REMEDATION SYSTEM EVALUATION

RISDON CORPORATION
DANBURY, CONNECTICUT

Report of the Remediation System Evaluation,
Site Visit Conducted at the Risdon Corporation Site
January 15, 2003

EPA 542-F-04-027
September 2004
www.epa.gov/tio
clu-in.org/optimization

FIGURE 1-1. AREA SURROUNDING THE RISDON FACILITY.

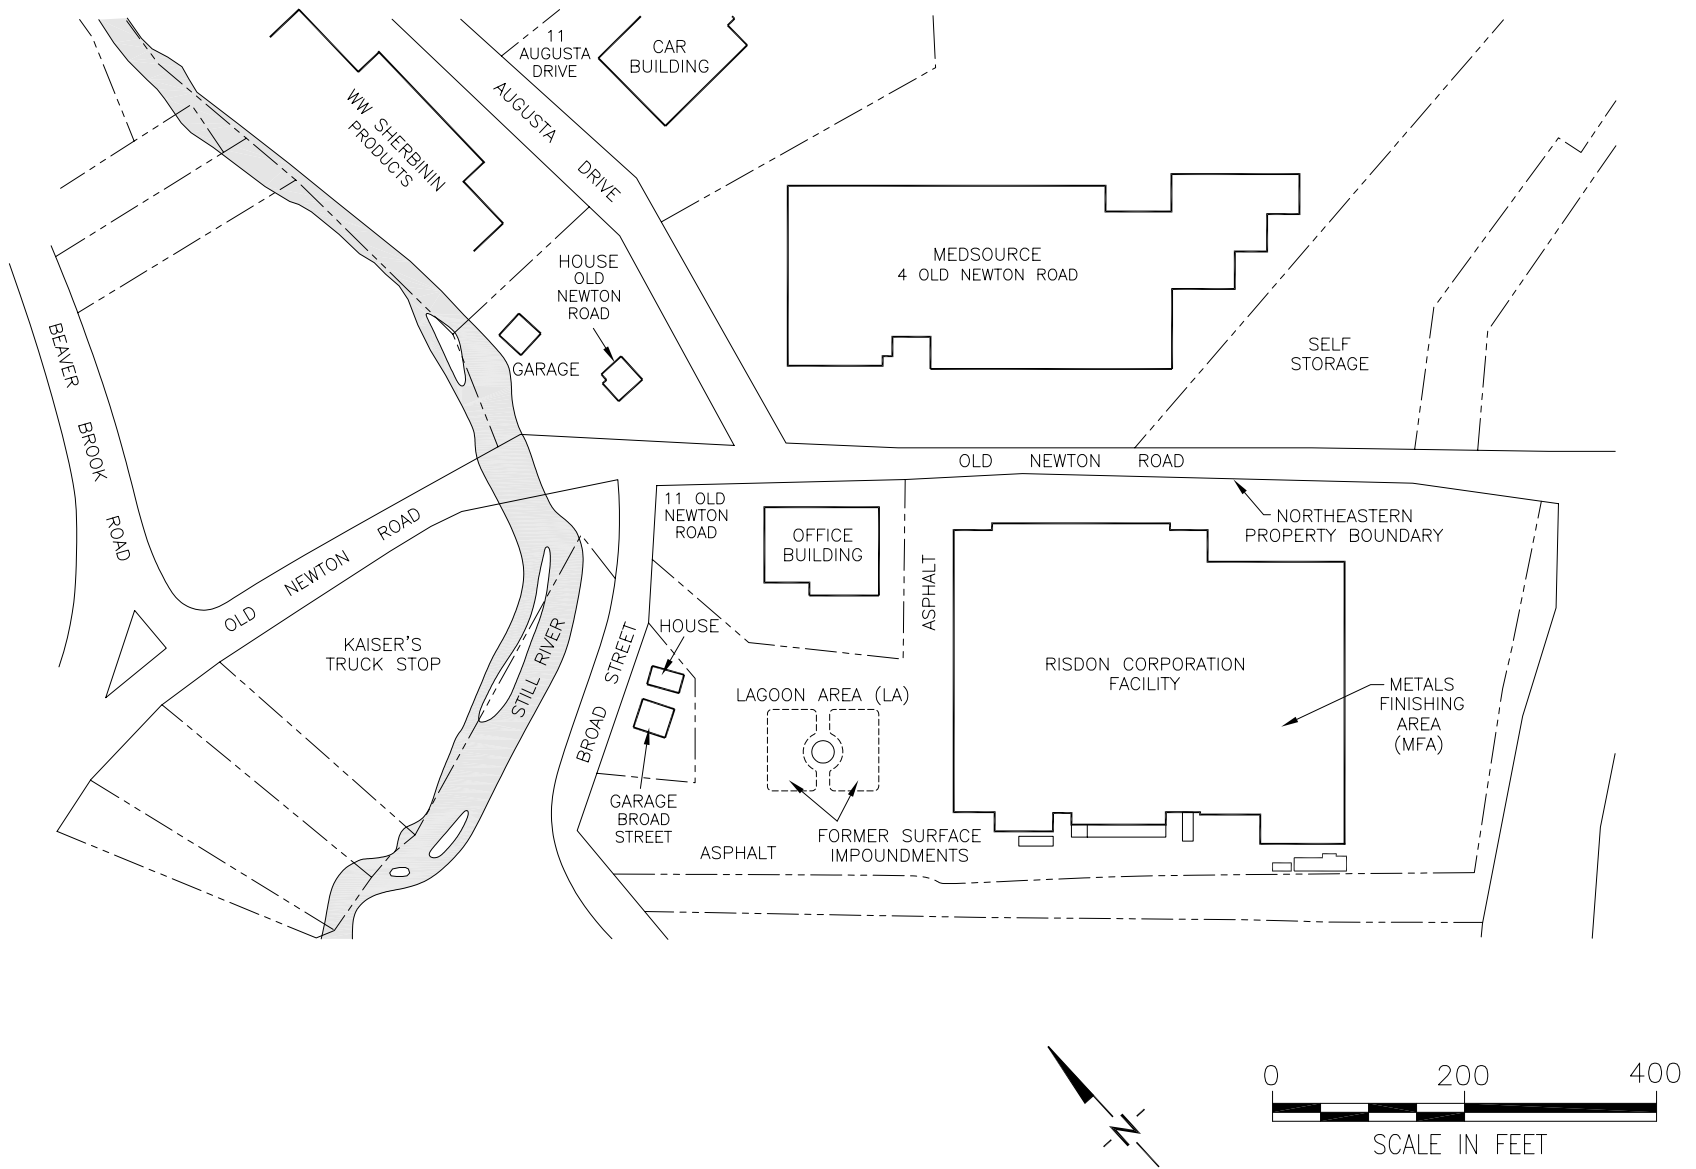
The property consists of 5-acre manufacturing facility surrounded by paved parking areas, including a paved parking area to the west of the facility that overlies a former surface impoundment area (the “lagoon area”). Figure 1-1 presents a map of the Risdon property and the surrounding area. The area surrounding the facility is primarily commercial or light industrial with interspersed residences. A Medsource facility is located across Old Newtown Road to the northwest, a residence is also located on Old Newtown Road to the north, and office space and a private residence/private iron works facility is located to the northwest on Broad Street. The Still River is located beyond these properties to the northwest, approximately 100 feet from the Risdon property.
